October 27, 2009

STAFF ASSESSMENT OF THE OYSTER CREEK
3-D FINITE ELEMENT ANALYSIS OF THE DRYWELL SHELL

**SUBJECT: REPORT ON THE 3-DIMENSIONAL FINITE ELEMENT ANALYSIS OF THE
 OYSTER CREEK NUCLEAR GENERATING STATION DRYWELL SHELL**

FIGURE 1 Oyster Creek Drywell Shell

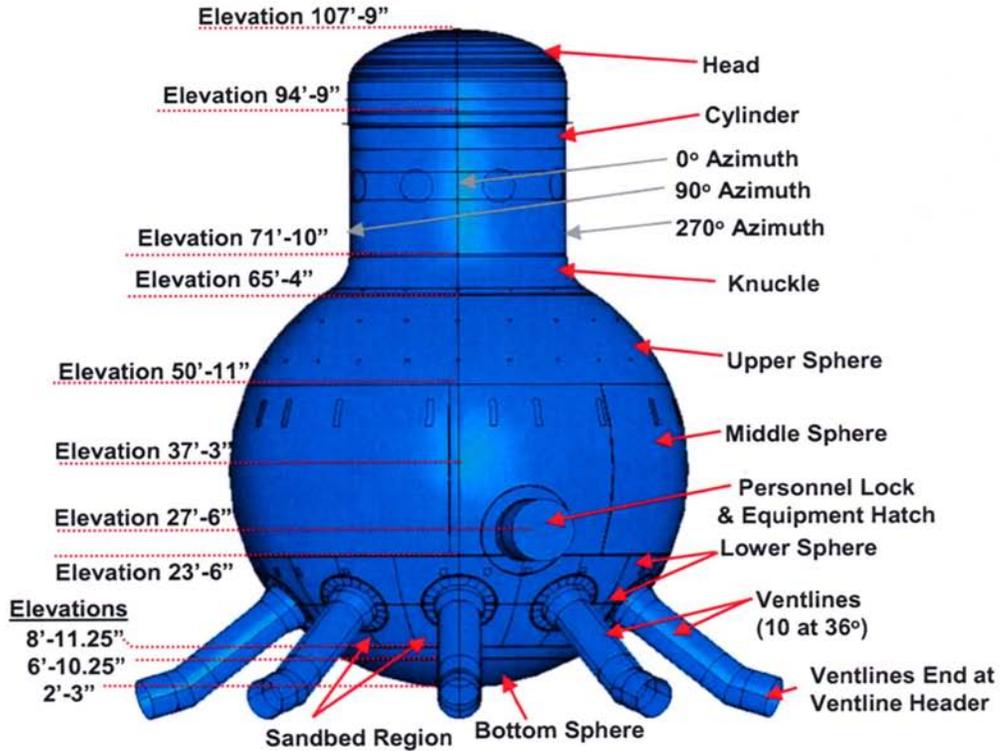
⁹ Elevations on the drywell shell are shown in Figure 1, above.

FIGURE 2 Schematic - Sand Bed Area

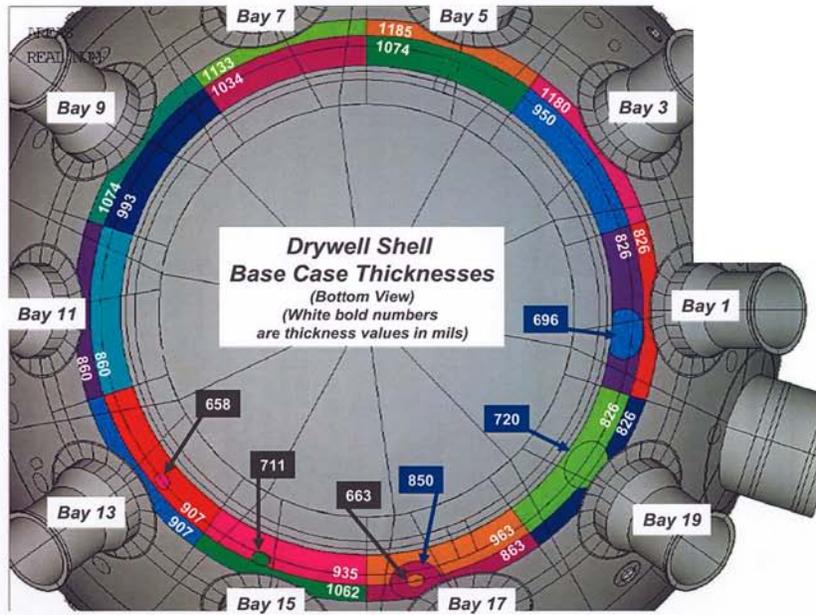
Case 1 (“S1”): Reduce the wall thickness of the defined locally thinned area in Bay 1 from 696 mils (see Figure 2) to 596 mils, keeping the general area of the thickness in Bay 1 constant (826 mils - as in 403R) with all other inputs the same as in the Base Case.

Case 2 (“S2”): Reduce the wall thickness of the general area in Bay 19 from 826 mils (see Figure 2) to 776 mils, keeping the thickness of the locally thinned area constant (720 mils) and all other inputs the same as in the Base Case.

To capture the potential uncertainties in identifying the location and degradation of the locally thinned areas, the applicant has reduced the thickness of the 51-inch diameter circle (see Figure 2) by 100 mils in Bay 1, the bay most affected by corrosion. As the UT measurements at certain elevations are not available in certain bays, in addition to the approach taken by the applicant in the Baseline analysis, the applicant has reduced the shell thickness by 50 mils in Bay 19 in S2. This will quantify the effects of thickness reduction in the sandbed region on the buckling safety factors. The staff finds the use of these sensitivity cases conservative and acceptable for considering the effect of the size and thickness of degraded areas on the available margin.
